ADDENDUM

April 3, 2020

ADDENDUM # 3 Bid 20C6, Waverley Elementary School - New Construction

FOUNDATION PLAN - AREA B 1/8" = 1'-0"

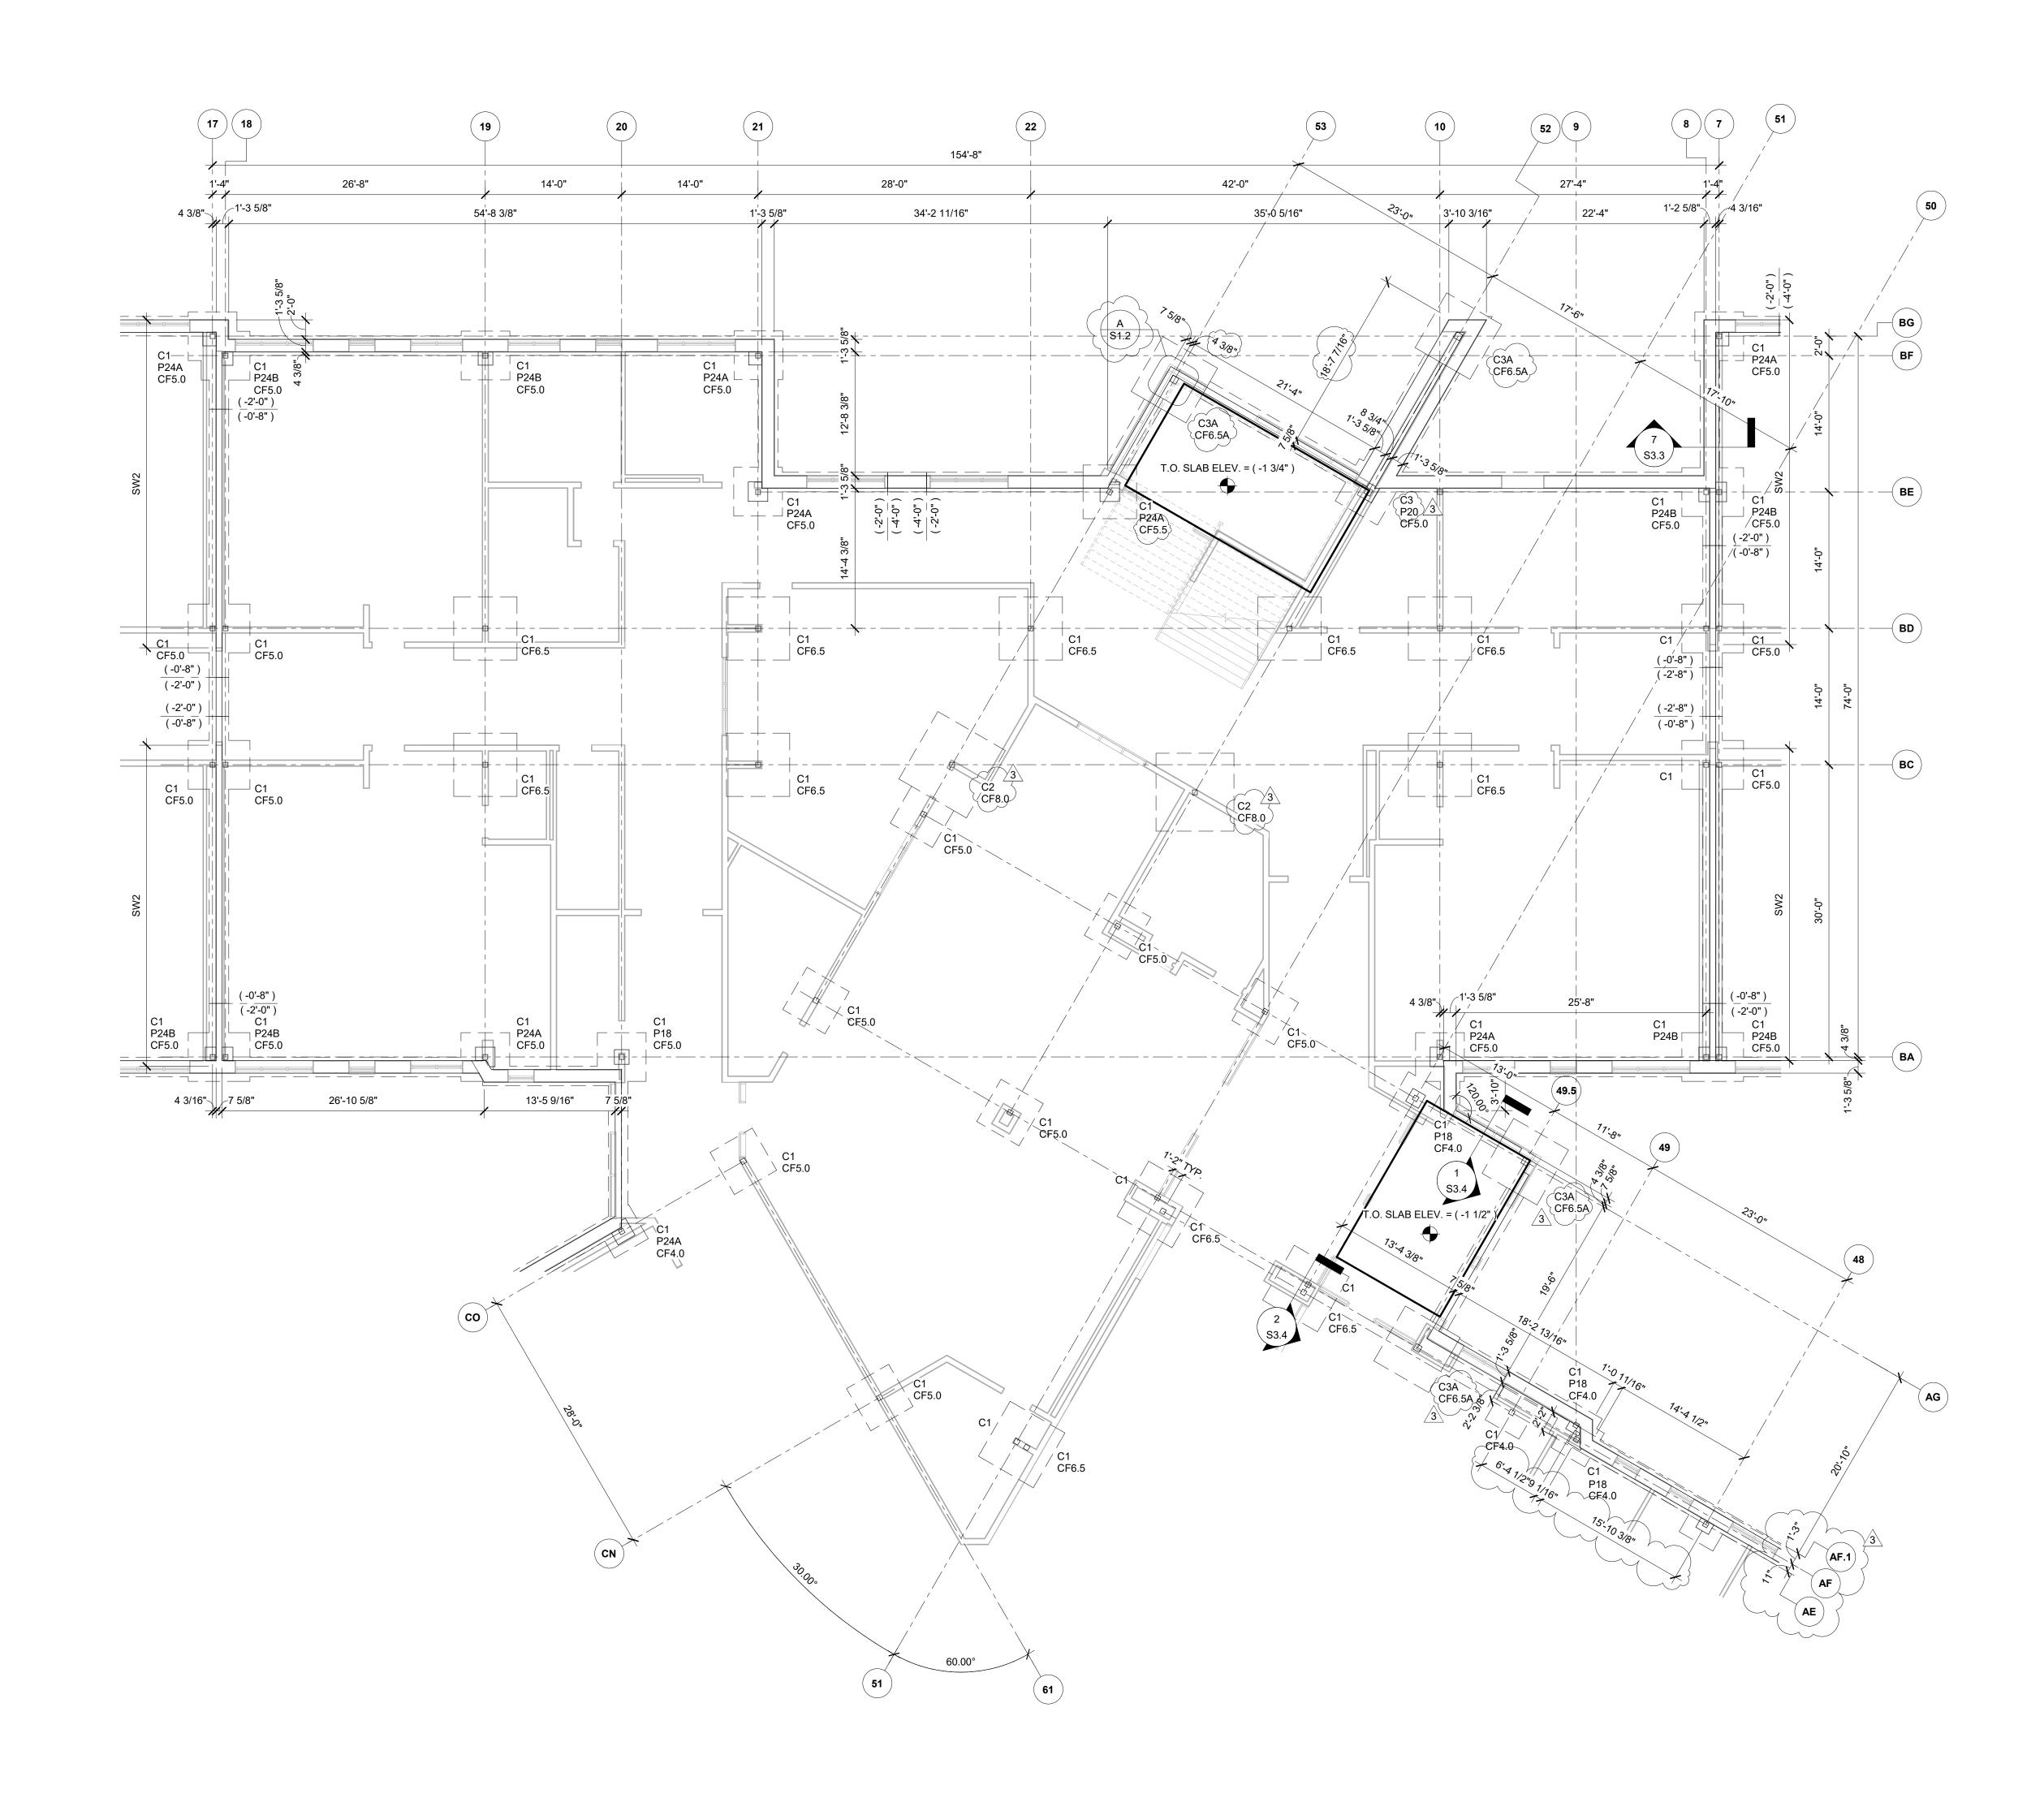
- **REVISED** select foundation wall locations.
 - DELETE Drawing Sheet S1.2 FOUNDATION PLAN AREA B; Issued for Bid, dated 03/06/2020. ADD Drawing Sheet S1.2 – FOUNDATION PLAN – AREA B; ADDENDUM #3 (Revision dated 04/03/2020).

ROOF FRAMING PLAN - AREA B

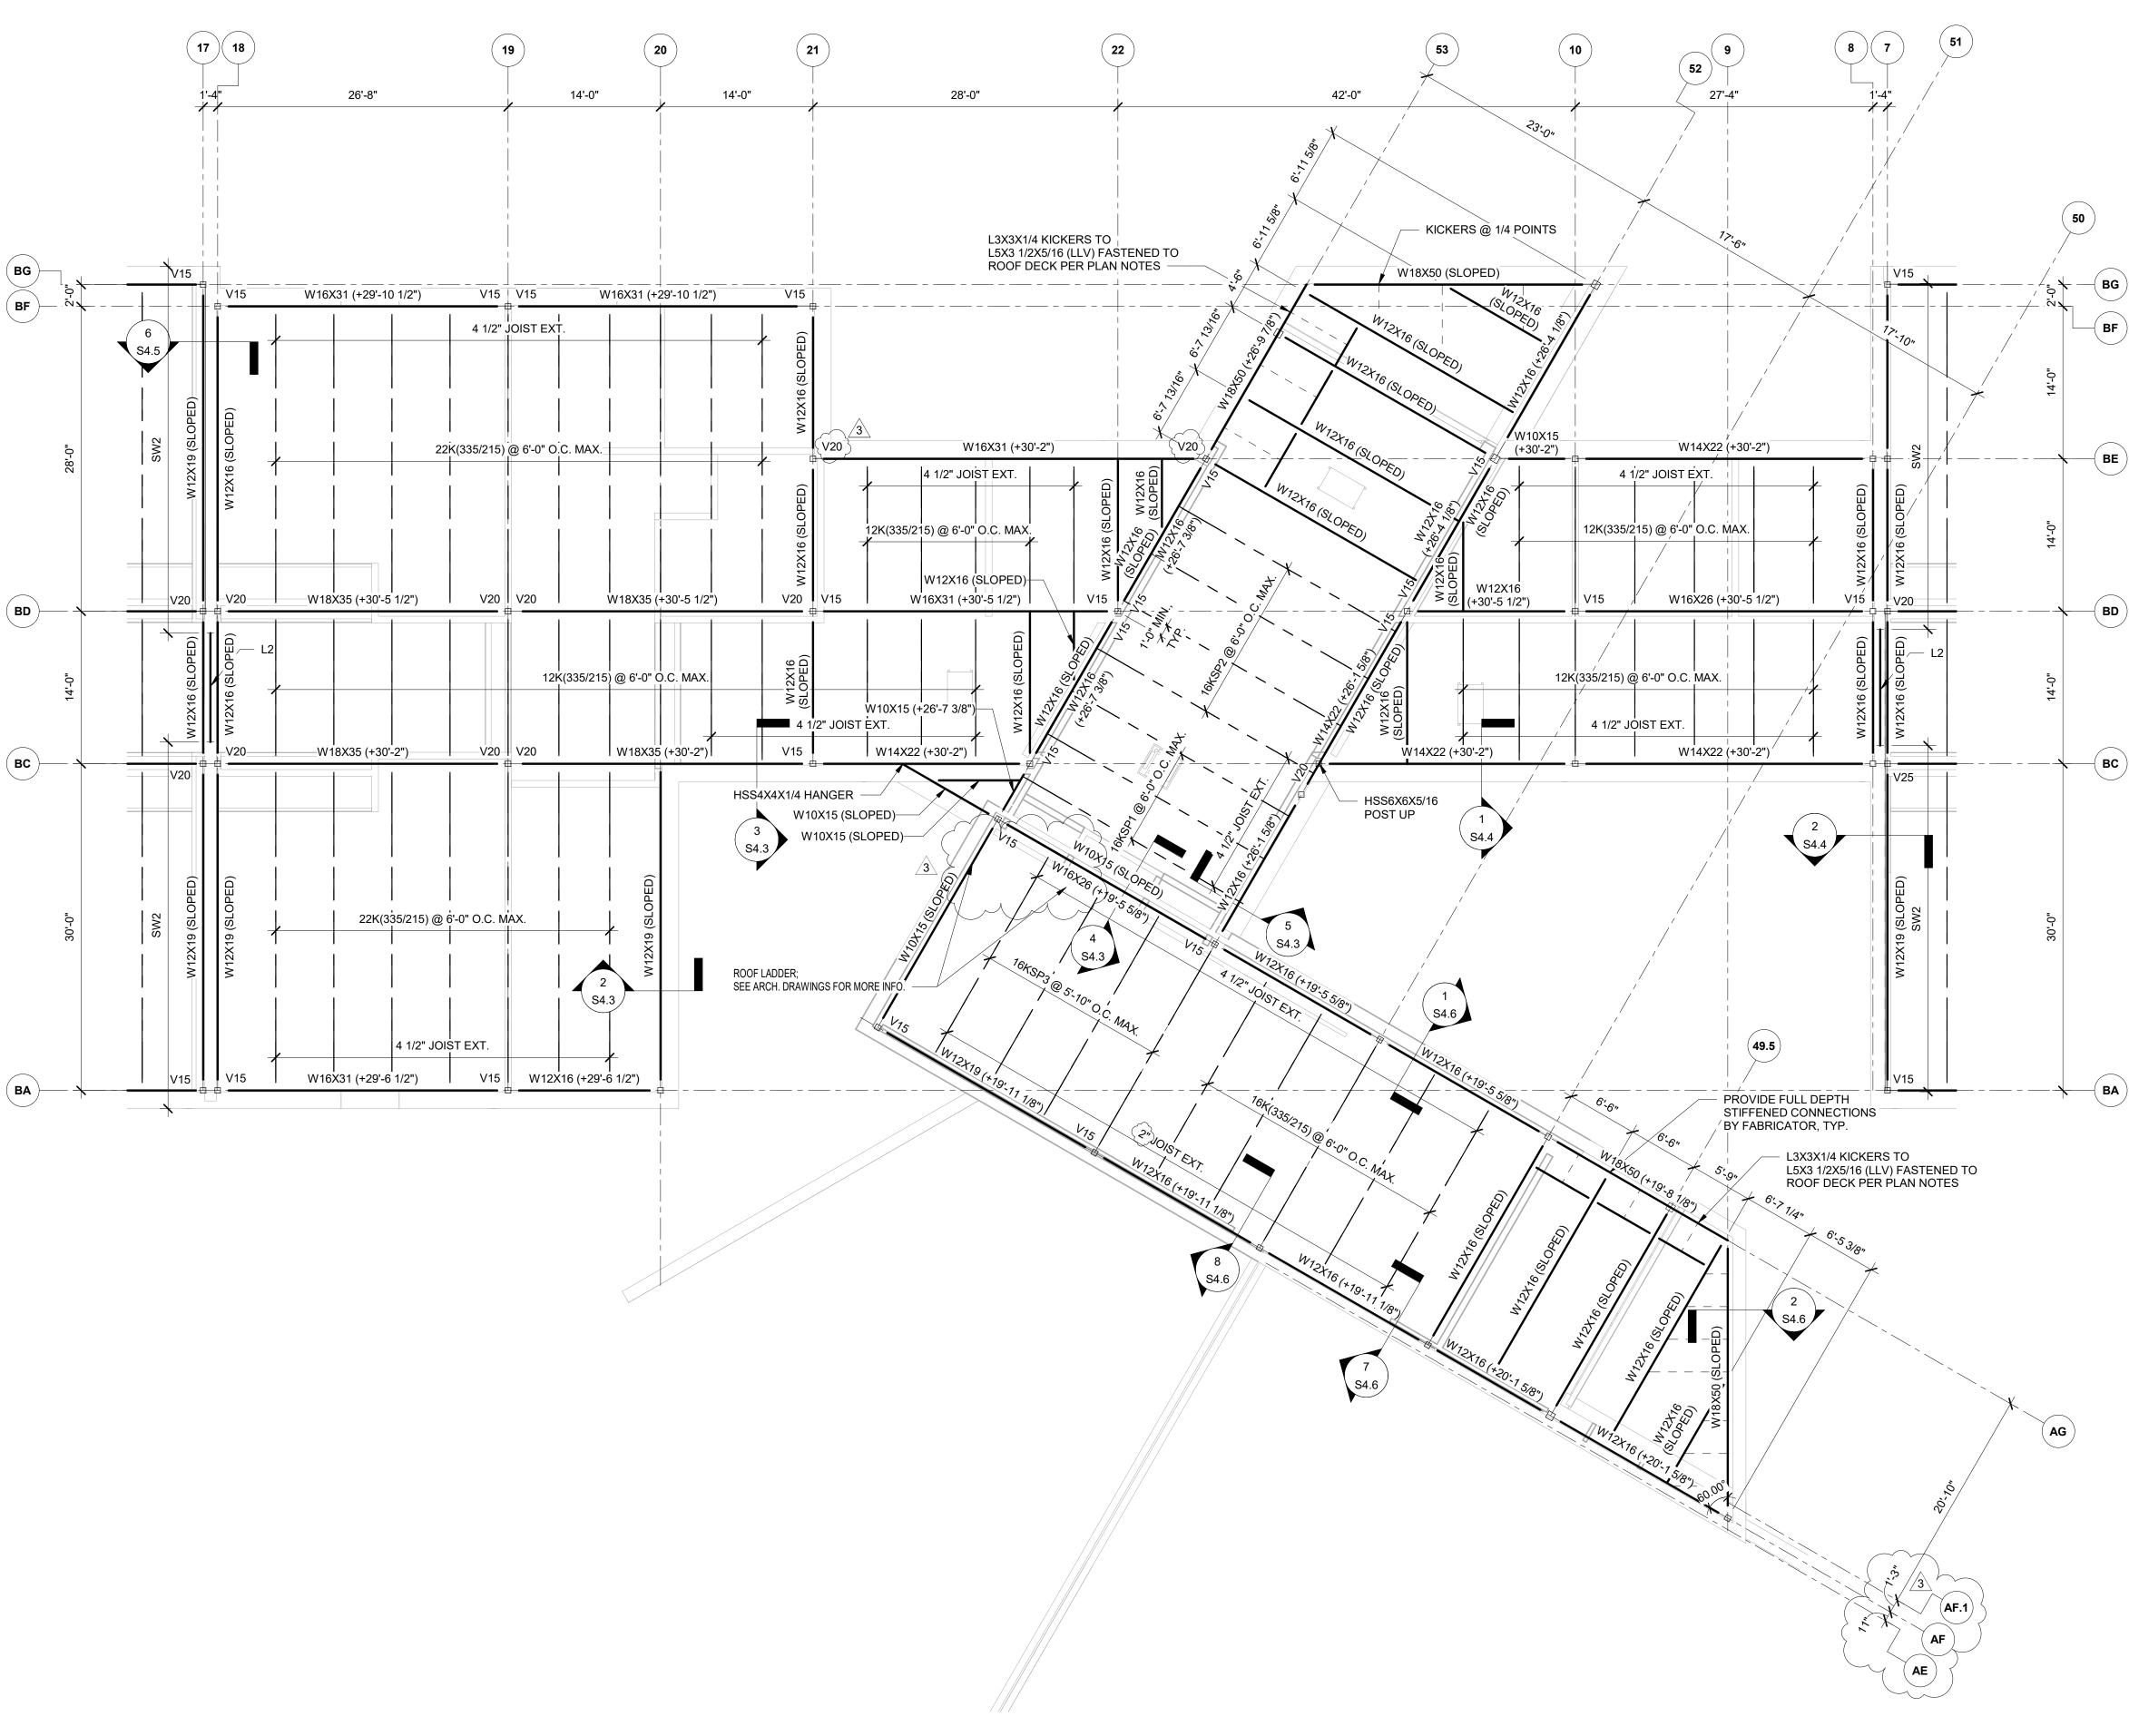
- REVISED select member sizes and section references at bus entry.
 - DELETE Drawing Sheet S1.13 ROOF FRAMING PLAN AREA B; Issued for Bid, dated 03/06/2020. ADD Drawing Sheet S1.13 – ROOF FRAMING PLAN – AREA B; ADDENDUM #3 (Revision dated 04/03/2020).

7 SECTION S3.3 1" = 1'-0"

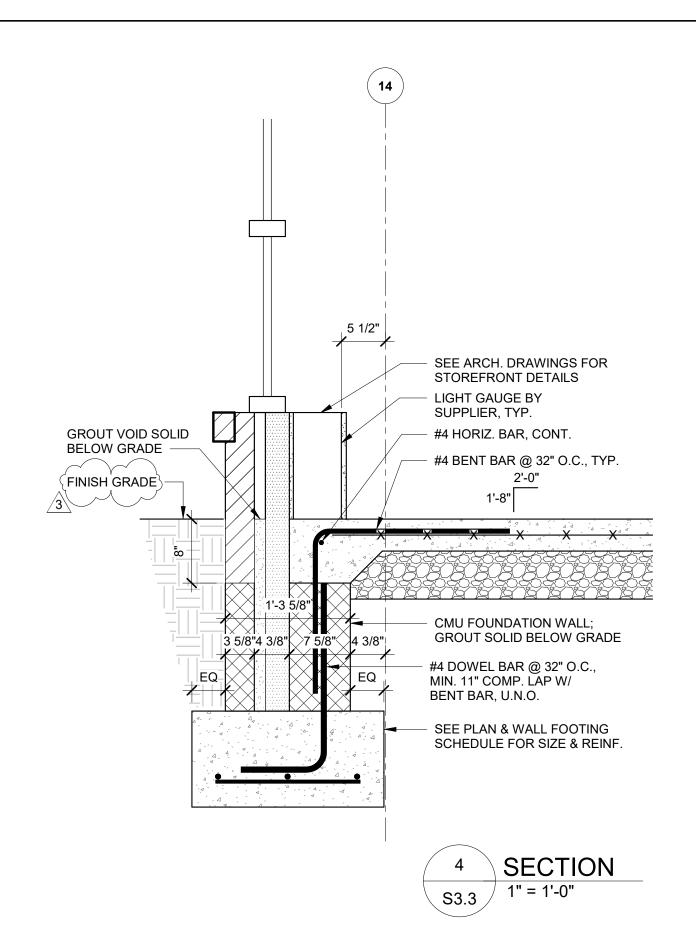
- **ADDED** loose lintel detail at 1" brick reveal.
 - DELETE Drawing Sheet S3.3 FOUNDATION SECTIONS; Issued for Bid, dated 03/06/2020. ADD Drawing Sheet S3.3 – FOUNDATION SECTIONS; ADDENDUM #3 (Revision dated 04/03/2020).

- REVISED dimensions at exterior labeled from "FINISH GRADE" for clarity.
 - REVISED Detail 6.
 - 7. **REVISE** Drawing Sheet S3.4 FOUNDATION SECTIONS; Issued for Bid, dated 03/06/2020.

SECOND FLOOR PARTIAL PLAN - AREA B - POWER

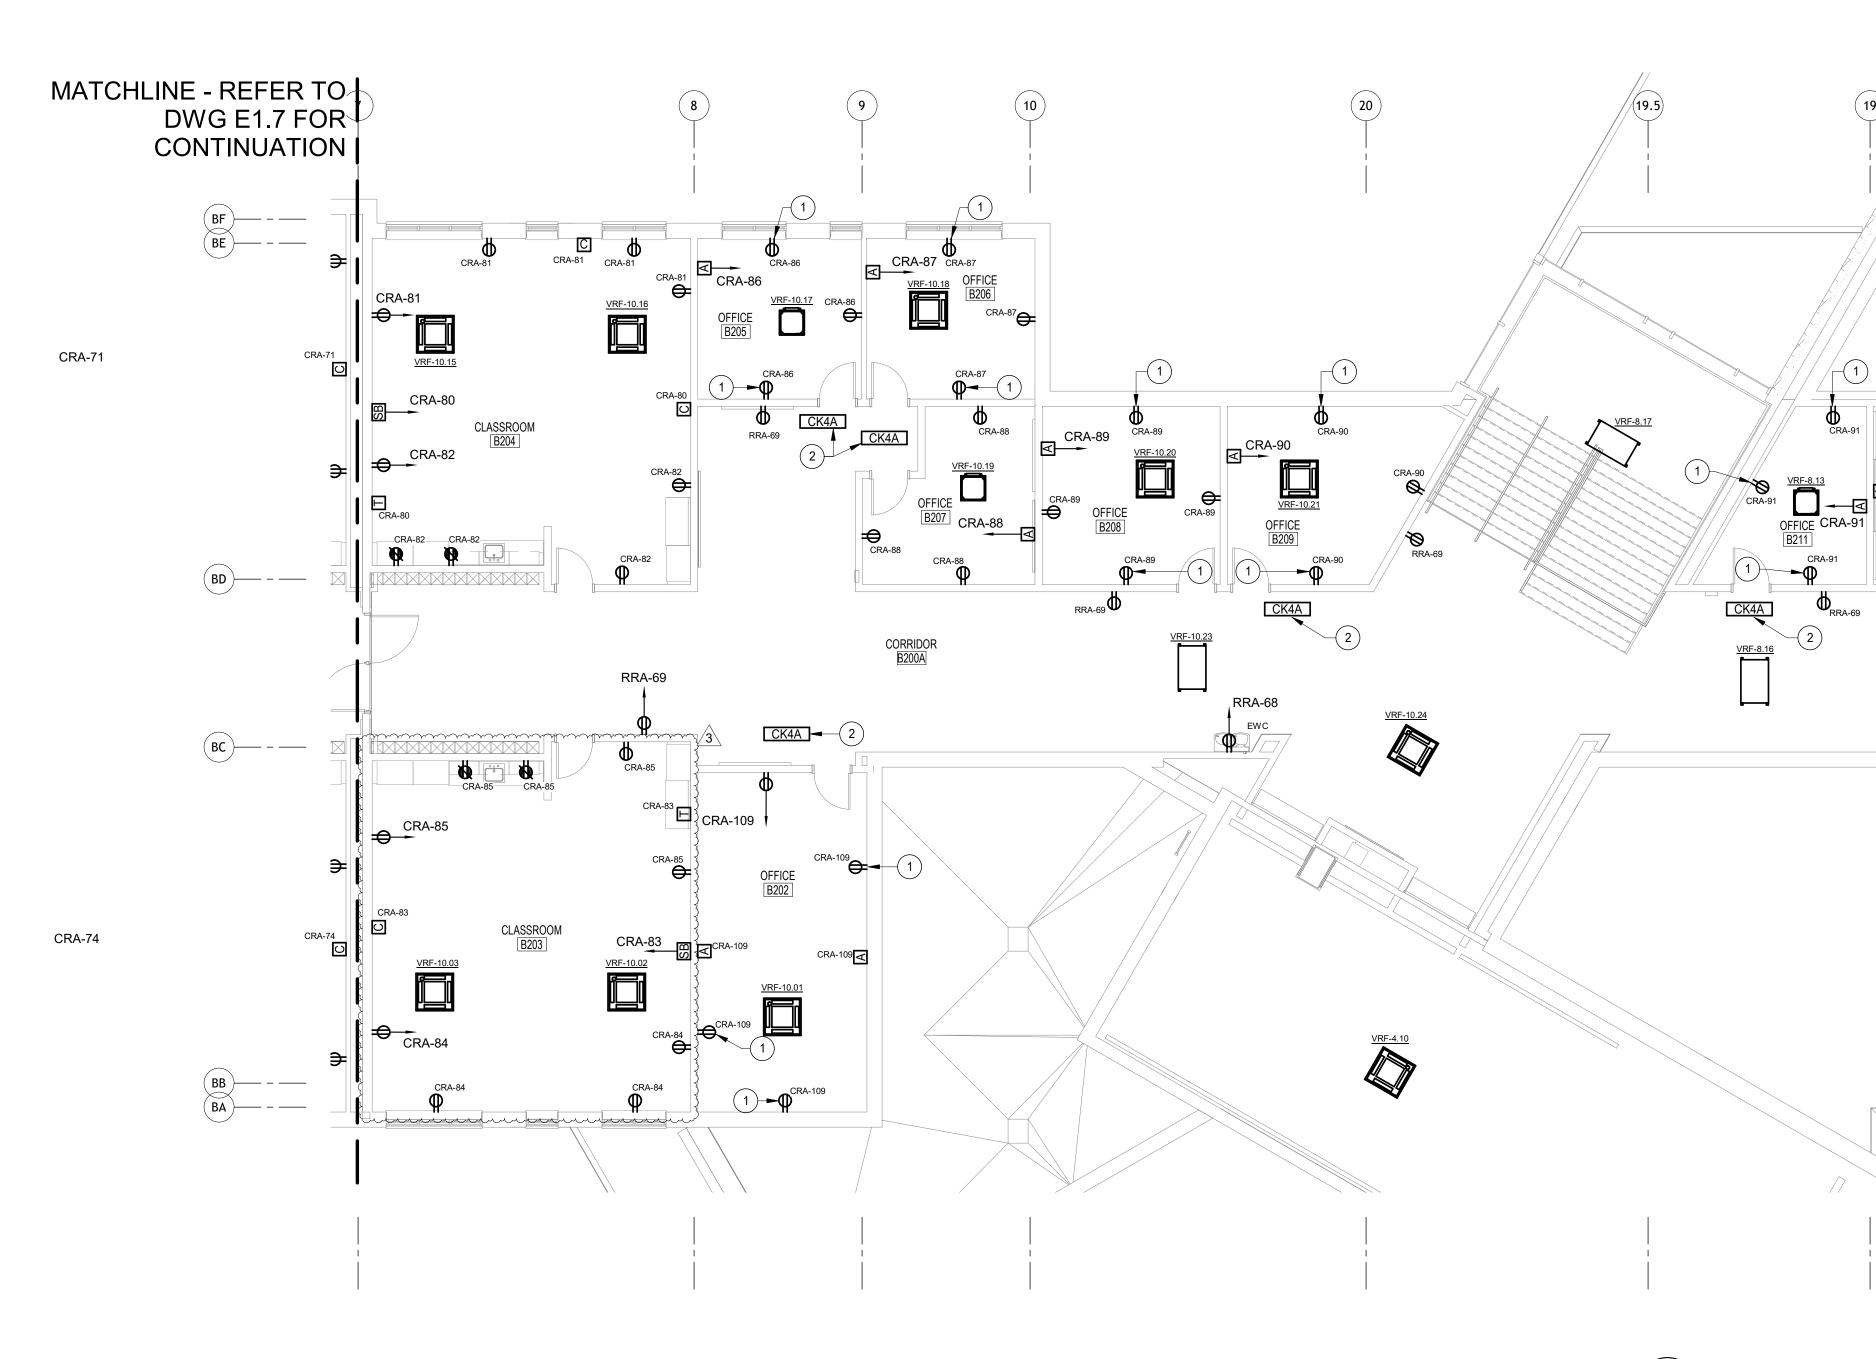
- **REVISED** classroom layouts as indicated.
- DELETE Drawing Sheet E1.8 SECOND FLOOR PLAN AREA B POWER; Issued for Bid, dated 03/06/2020; ADD Drawing Sheet E1.8 – SECOND FLOOR PLAN – AREA B – POWER; ADDENDUM #3 (Revision dated 04/03/2020).

- **REVISED** classroom layouts as indicated.
- DELETE Drawing Sheet E1.9 SECOND FLOOR PLAN AREA F POWER; Issued for Bid, dated 03/06/2020; ADD Drawing Sheet E1.9 – SECOND FLOOR PLAN – AREA F – POWER; ADDENDUM #3 (Revision dated 04/03/2020).
